Access Compliance Report

Public Rights-of-Way

(Curb Ramps)

Intersection ID: 14401	Main Street: BAXTER_ST	Cross Street: BALDWIN_AV	Location: SW
ADA ID: AFCA6B5E12A9	Ramp Type: PerpDiag	Initial Pass/Fail: Fail	Overall Compliance: No
Severity Score: 13.75			
Codes/Mitigation Info/Possible Solution		Field Measurements/Component Compliance

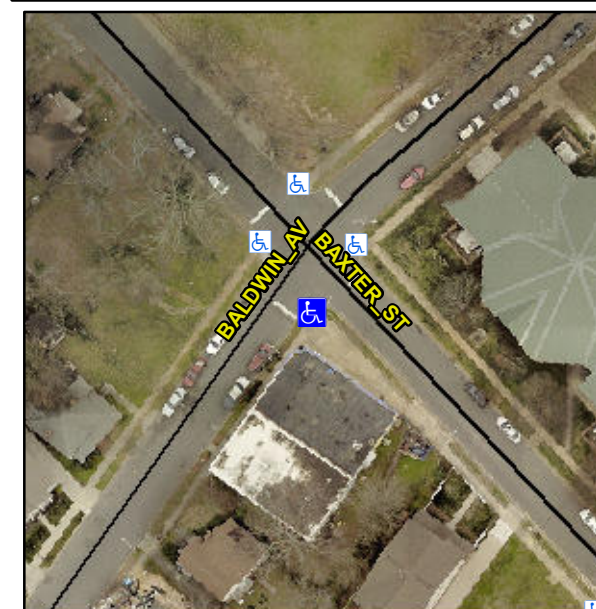
Not Found, R304.2.2, R304.5.3

Compliance	Description	Data	Compliance	Description	Data
N/A	Ramp Length (in)	64.0	No	Ramp Slope (%)	8.8
Yes	Ramp Width (in)	48.0	No	Ramp XSlope (%)	3.3
N/A	Flare Type LT	N/A	N/A	Flare Type RT	N/A
N/A	Flare Slope LT (%)	N/A	N/A	Flare Slope RT (%)	N/A
N/A	Flare Traversable LT?	N/A	N/A	Flare Traversable RT?	N/A
N/A	Landing Length (in)	N/A	N/A	DWS Provided?	N/A
N/A	Landing Width (in)	N/A	N/A	DWS Contrast?	N/A
N/A	Landing Slope (%)	N/A	N/A	DWS Length (in)	N/A
N/A	Landing X Slope (%)	N/A	N/A	DWS Full Width?	N/A
N/A	Landing Curb? (Y/N)	N/A	N/A	DWS Offset (in)	N/A
N/A	Shared Landing?	N/A			
N/A	Gutter Ponding?	N/A	N/A	Gutter Slope (%)	N/A
N/A	Gutter Lip Ht (in)	N/A	N/A	Gutter X Slope (%)	N/A
N/A	Painted X Walk1?	No	N/A	Painted X Walk2?	No
	X Walk 1 Direction	To NE		X Walk 2 Direction	To NW
N/A	X Walk 1 Width (in)	N/A	N/A	X Walk 2 Width (in)	N/A
	X Walk 1 Slope (%)	3.3		X Walk 2 Slope (%)	3.3
	X Walk 1 X Slope (%)	0.3		X Walk 2 X Slope (%)	2.0

N/A	Ramp inside XWalk1?	N/A	N/A	Ramp inside XWalk2?	N/A
	Road Slope (%)	2.2	N/A	Clear Space?	N/A
	Road X Slope (%)	0.6	N/A	Clear Space to XWalk (in)	N/A
N/A	Any Obstructions?	N/A	N/A	Storm Grate/Utility Hazard?	N/A
	Obstruction Type			Storm Grate/Utility Type	
		N/A			N/A
			Yes	Surface Condition? (G/P)	Good

Remove & Replace Curb Ramp With Two New Directional Ramps or Equivalent.
